MONTLIMAR PLACE SUBDIVISION, **RESUBDIVISION OF**

APPLICATION NUMBER 9 DATE July 20, 2006

REQUEST Subdivision

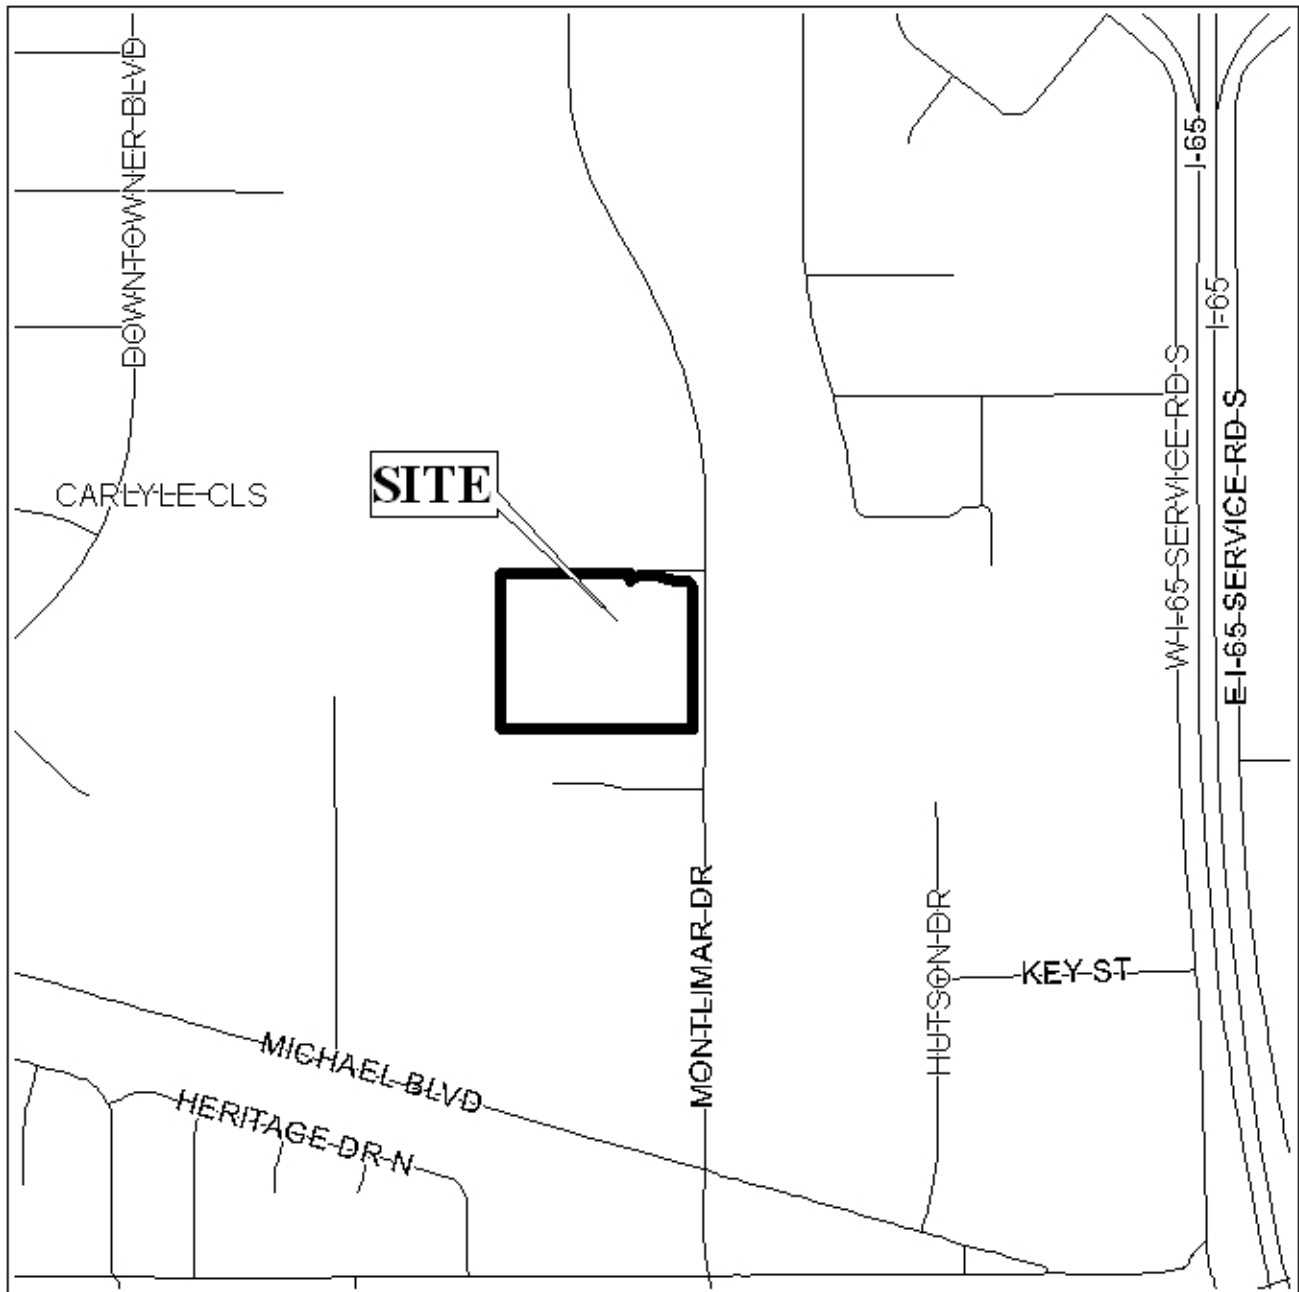
The site fronts Montlimar Drive, a minor street with an 80-foot right-of-way, and Carlyle Close East, a street stub approximately 250-feet in length with a variable right-of-way width, which terminates into the subject property. The subject property also shares a non-exclusive reciprocal easement with the adjoining property to the North. The minimum right-of-way width for a minor street with curb and gutter, such as Carlyle Close East, is 50-feet, or 25-feet in each direction as measured from the centerline of the right-of-way. Since the existing right-of-way does not meet the required minimum width, the dedication to provide 25-feet from the center line of Carlyle close East should be required

Access management is a concern due to potential vehicular movement on Carlyle Close East. Lot 1, with approximately 330-feet frontage on Montlimar Drive, should be limited to two curb-cuts onto Montlimar Drive. Lot 3, with frontage on Montlimar Drive and Carlyle Close East, should be limited to one curb-cut onto Montlimar Drive and share a curb cut with Lot 2 (25-feet street frontage) onto Carlyle Close East. The size, design and location of all curb-cuts must be approved by the Traffic Engineering and conform to AASHTO standards. Since Lot 2 and Lot 3 would share access an Administrative PUD would be required.

Additionally, compliance with the buffer requirements of the Zoning Ordinance should be required from adjacent residential uses.

The plat is recommended for Tentative Approval subject to the following conditions: 1) the dedication of sufficient right-of-way, to provide 25-feet from the centerline of Carlyle Close East; 2) placement of a note on the Final Plat stating that Lot 1 is limited to two curb-cuts along

Montlimar Drive, with the size, location and design to be approved by Traffic Engineering and conform to AASHTO standards; 3) placement of a note on the Final Plat stating that Lot 3 is limited to one curb cut to Montlimar Drive, and Lot 2 and Lot 3 share a common curb cut to Carlyle Close East, with the size, location and design of all curb-cuts to be approved by Traffic Engineering and conform to AASHTO standards; 4) the submission of an Administrative Planned Unit Development application to allow the shared access by Lot 2 and 3; 5) compliance with the Buffer Requirements of the Ordinance; and 6) full compliance with all other municipal codes and ordinances.
